UNITED STATES NUCLEAR REGULATORY COMMISSION'S  
ADVISORY COMMITTEE ON REACTOR SAFEGUARDS

June 19, 2008

7 SUBCOMMITTEE ON ESBWR

7 It is my honor to be here today to present  
8 to you an overview and a summary of Sections 3.7 and  
9 3.8 of ESBWR standard plan design.

ESBWR Horizontal SSE Design Ground Spectra at Foundation Level

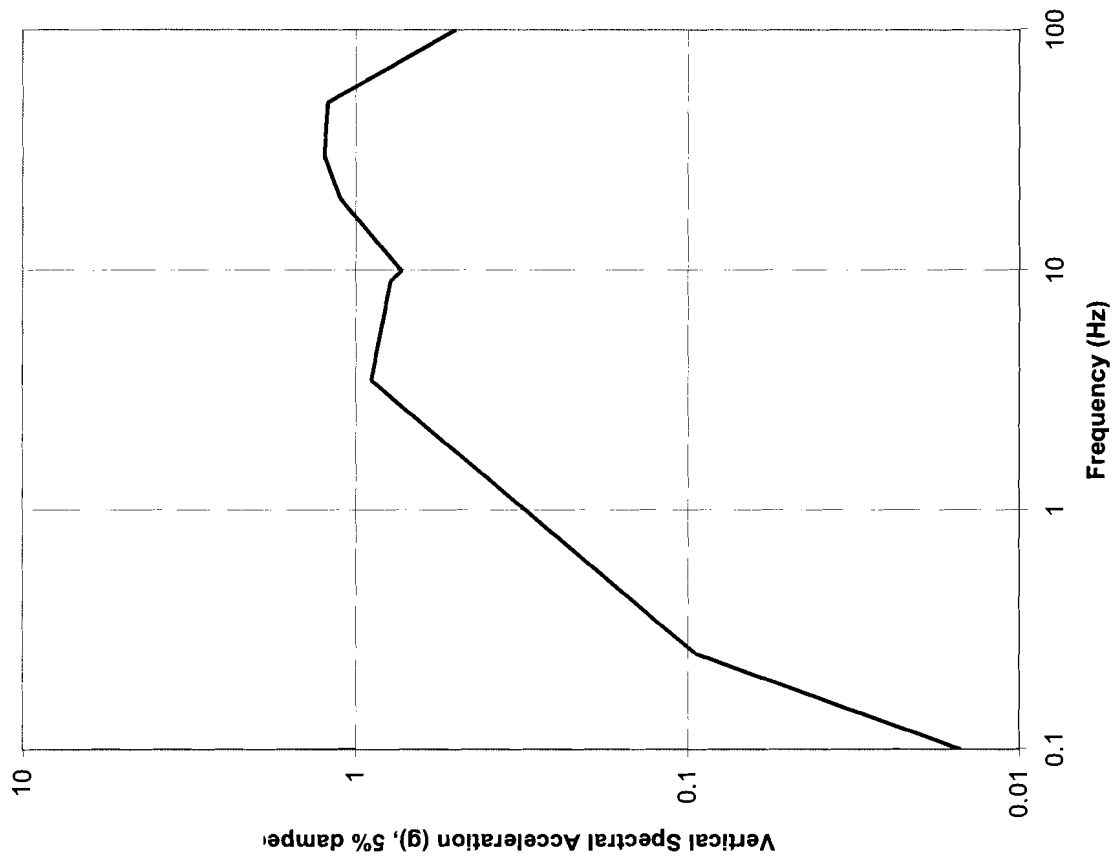
3 CHAIRMAN CORRADINI: So can I ask a less  
4 educated question on this? So just to make sure. So  
5 what we're going to see today is this stylized  
6 spectrum which adds the North Anna component? But for  
7 Chapter 19 you've taken away the North Anna component  
8 and have a different stylized curve? Pardon my  
9 simplified --

9 CHAIRMAN CORRADINI: Okay. But in Chapter  
10 19 you remove the black line at the lower frequencies  
11 and replace it with something close to the red line  
12 that is up there?

3 MEMBER ARMIJO: It would help a lot, I  
4 think, if somebody would just make a better figure  
5 showing how this double-hump is created. There are  
6 actually two different spectra and they're combined.  
7 And that makes it a lot easier to understand.

13 MR. LIU: Right. But just for the purpose  
14 to show the conservatisms in the design which is based  
15 on that design curve.
